**ADDENDUM NO. 4
JUICE BUILDING PHASE 1
2% MBE PARTICIPATION**

**'JUICE' BUILDING
3975 DAYTON PARK DR.
DAYTON, OH 45414**

**PHASE 1 ALTERATIONS AND OCCUPANCY
ADDENDUM 04**

Phase 1 Improvements For:
Juice Building
Project #2A-17774
3975 Dayton Park Dr.
Dayton, OH 45414

E3.1

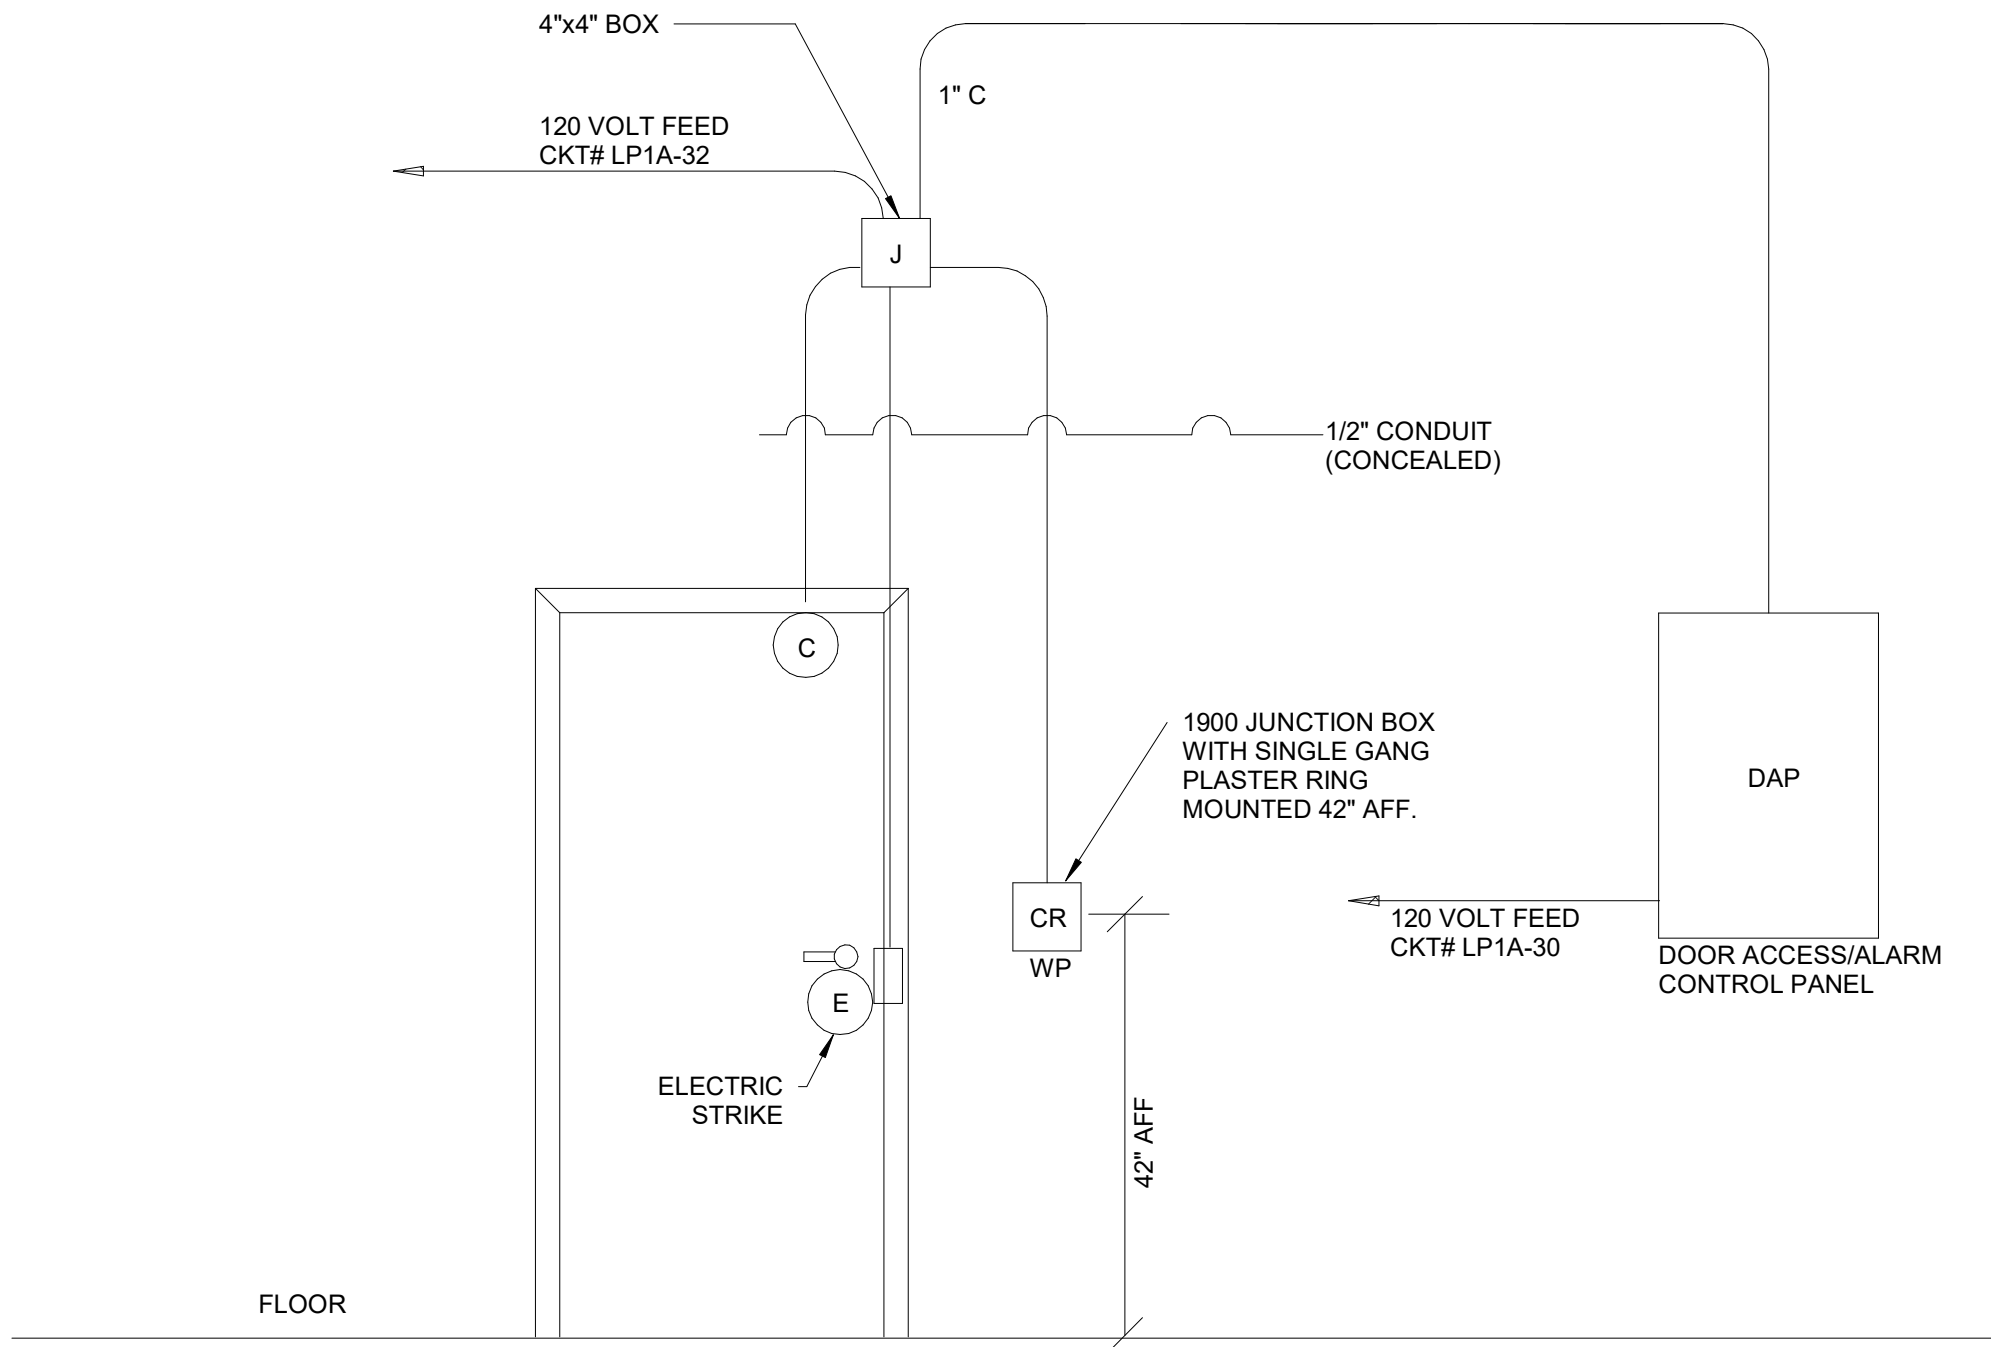
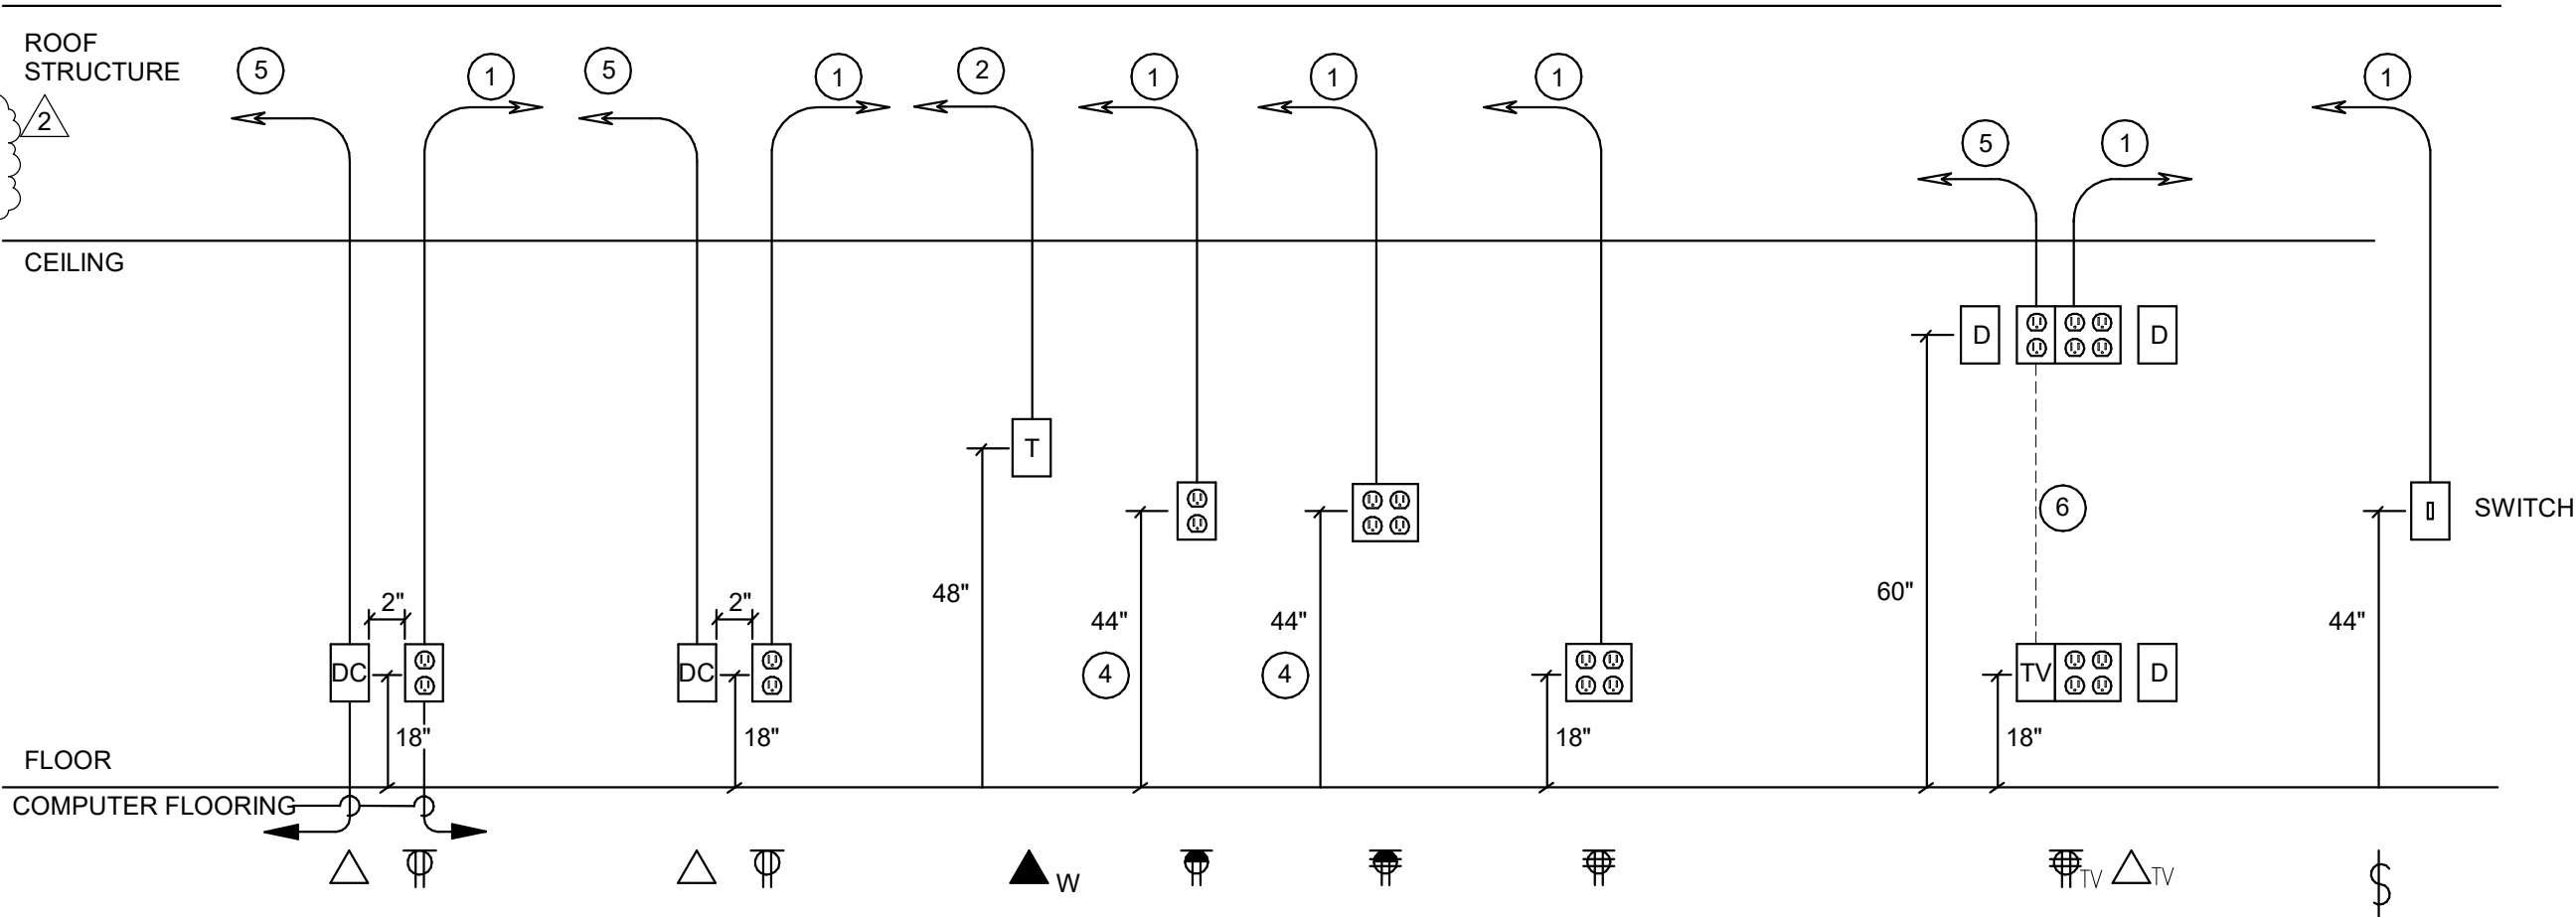
5. Sheet E3.1: REPLACE this sheet with the version attached to this addendum. Additional information added for data cabling connections. CLARIFICATION: Data cabling, racks and equipment are by Owner. EC is responsible for boxes, conduits and pull strings per the electrical drawings / specifications.
